**UMMC PROJECT NO. 409-007
FIRE PROTECTION CENTRAL CORE
UNIVERSITY OF MISSISSIPPI MEDICAL CENTER
JACKSON, MISSISSIPPI**

Addendum No. 1

August 5, 2026

This addendum forms a part of the contract documents and modifies the original plans and specifications dated June 12, 2026.

sheet no.
ADE-001
of

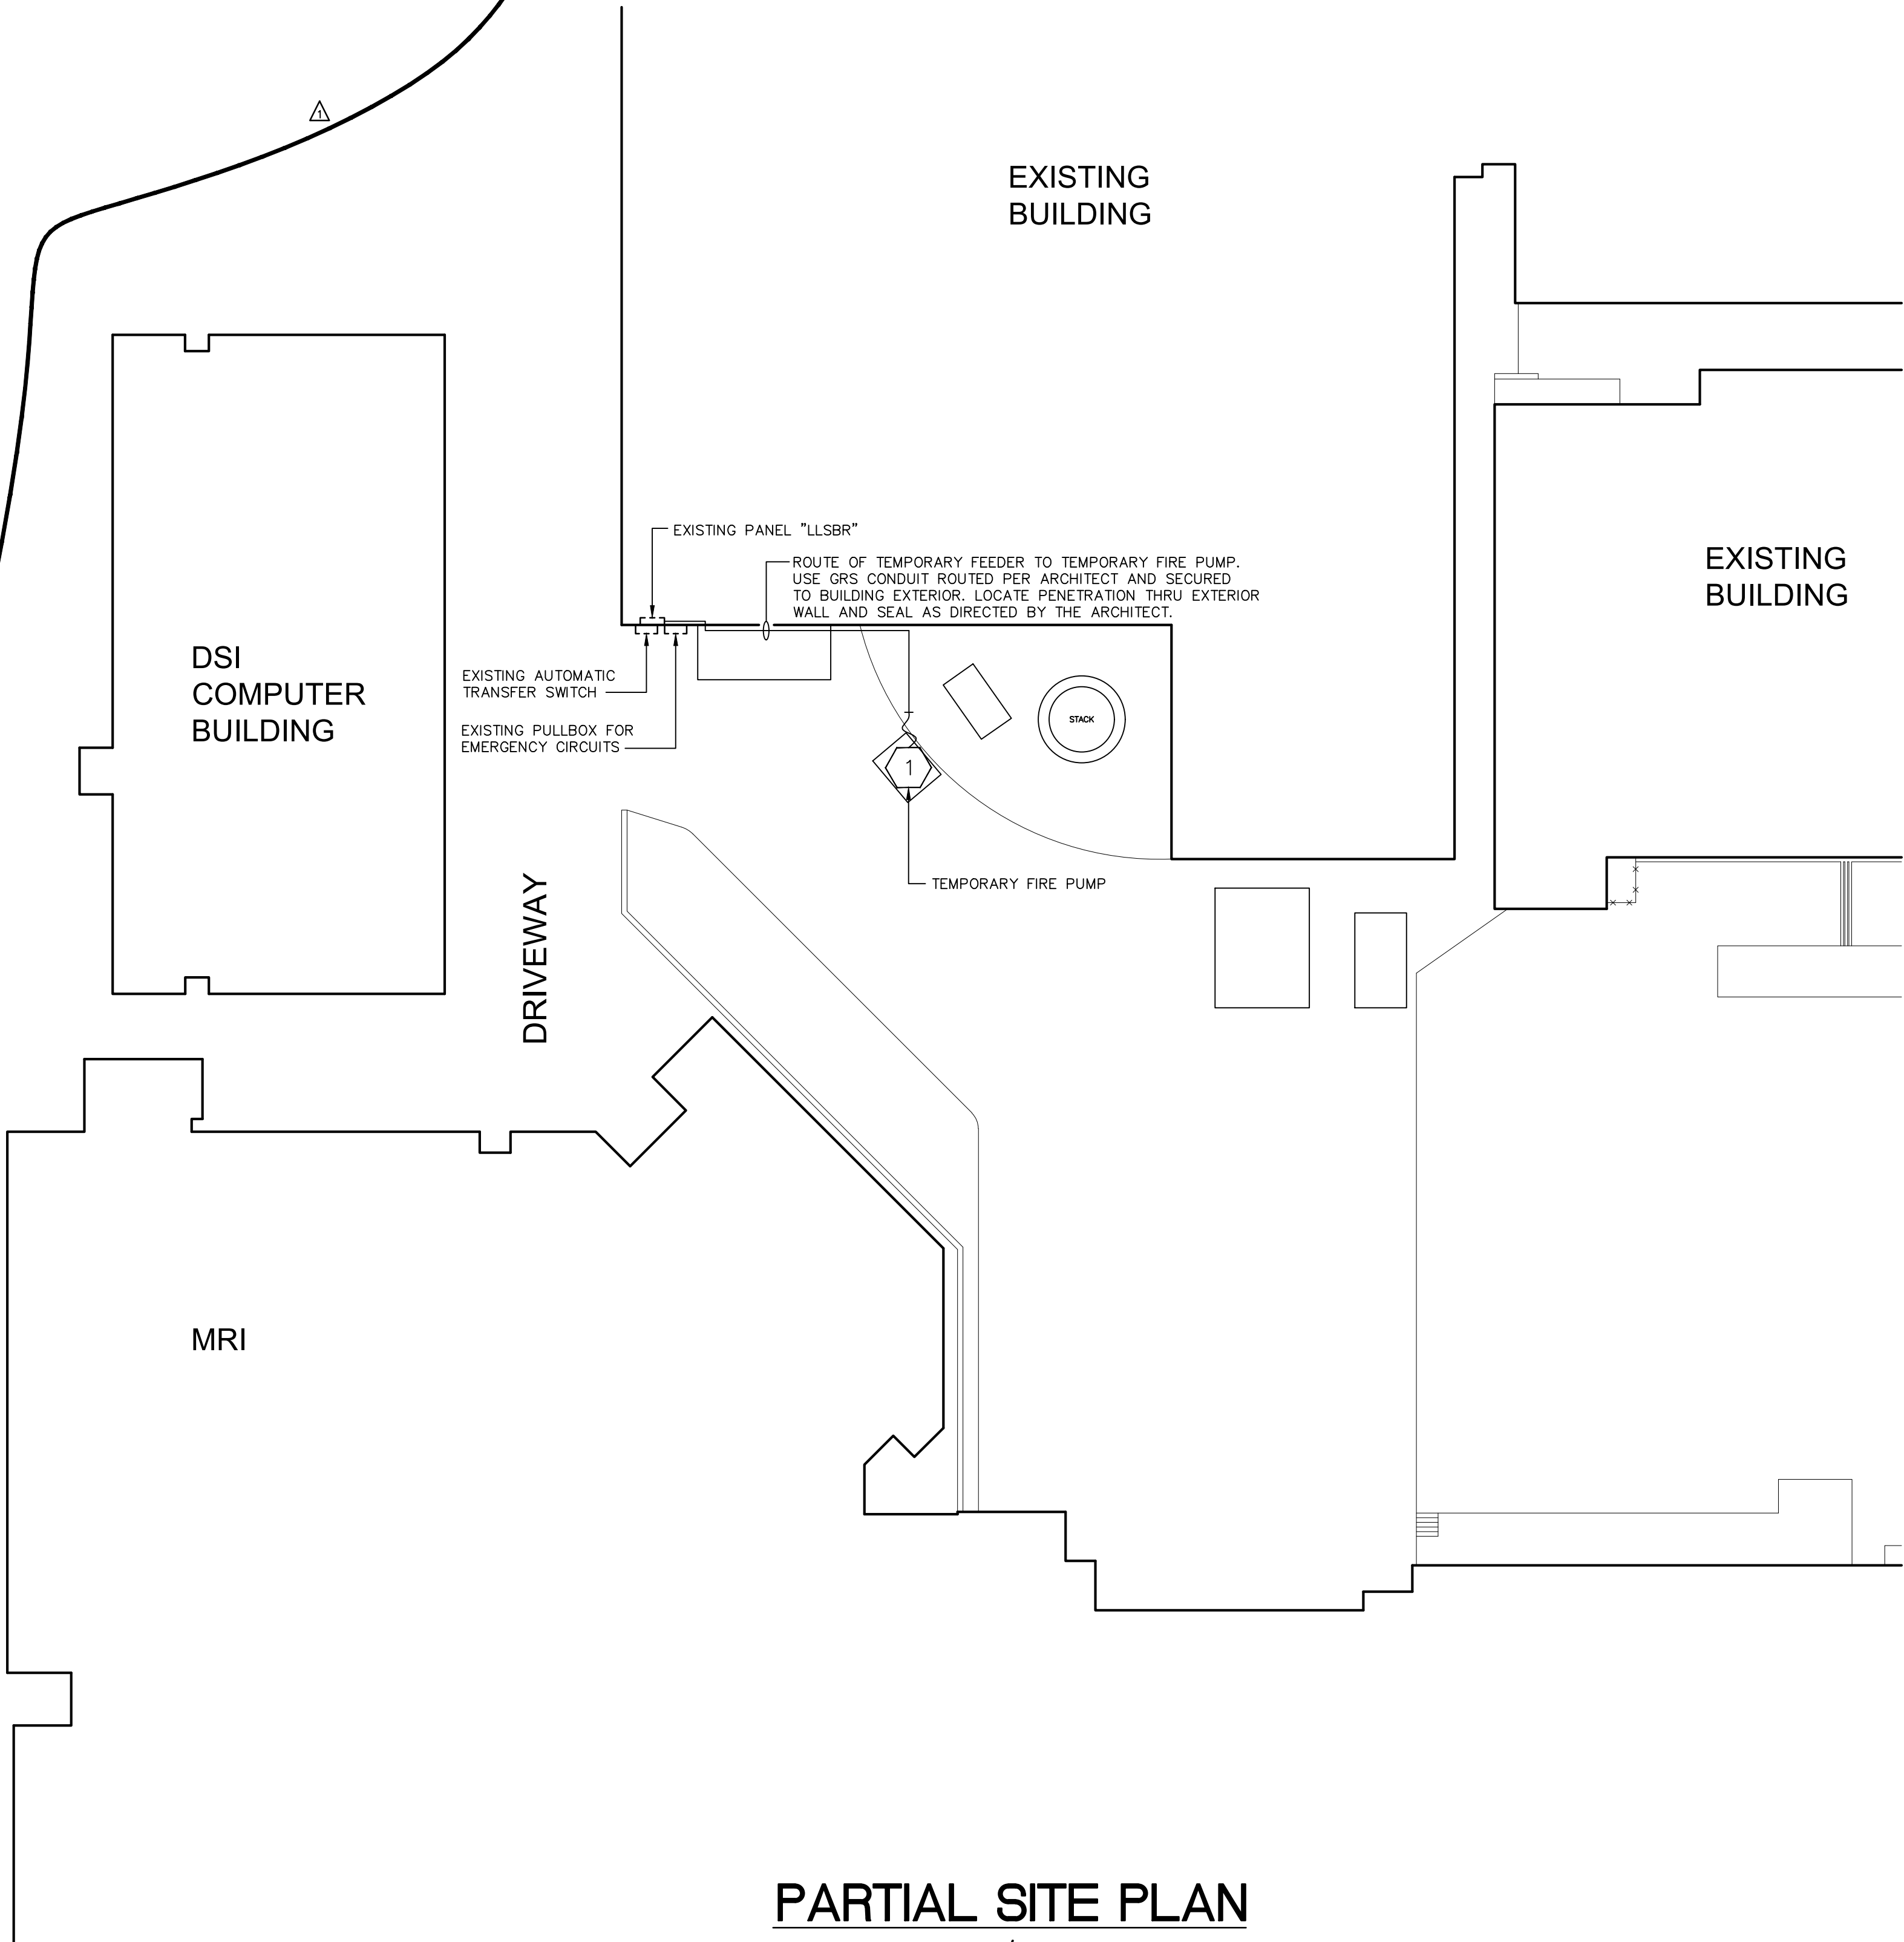
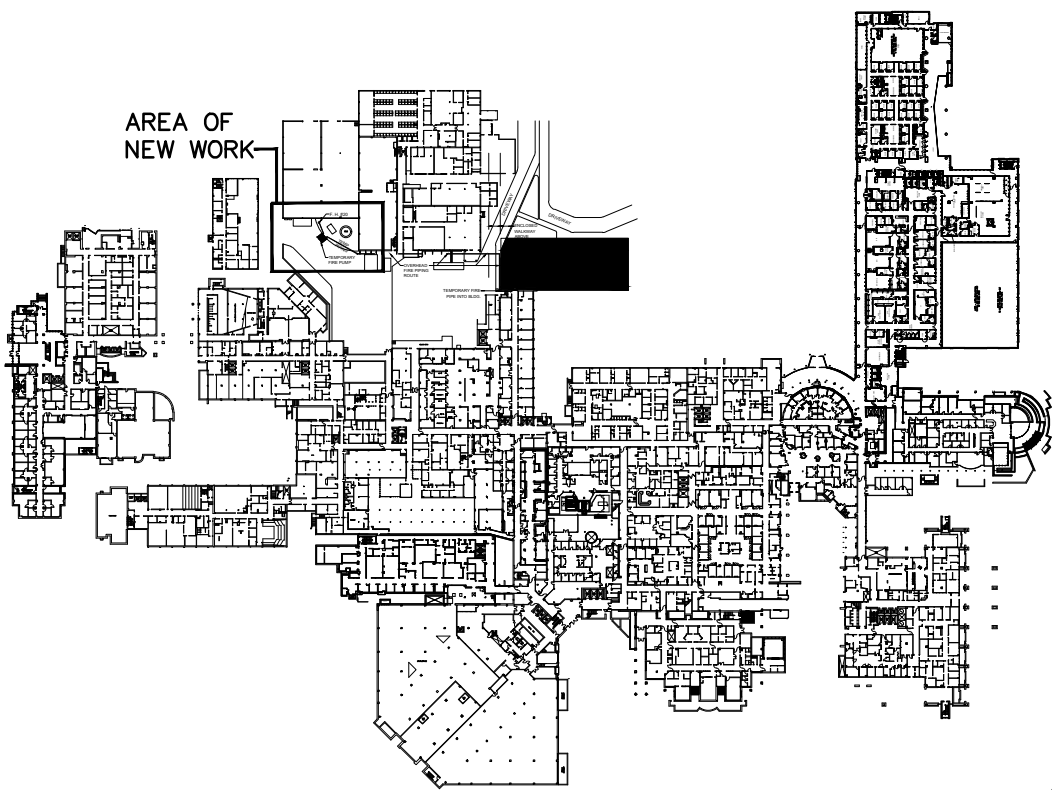
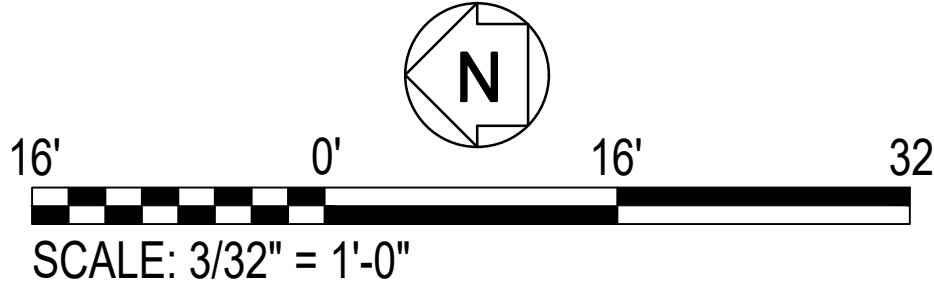
1. See new added sheet ADE001, Partial Site Plan, for connection to temporary fire pump.
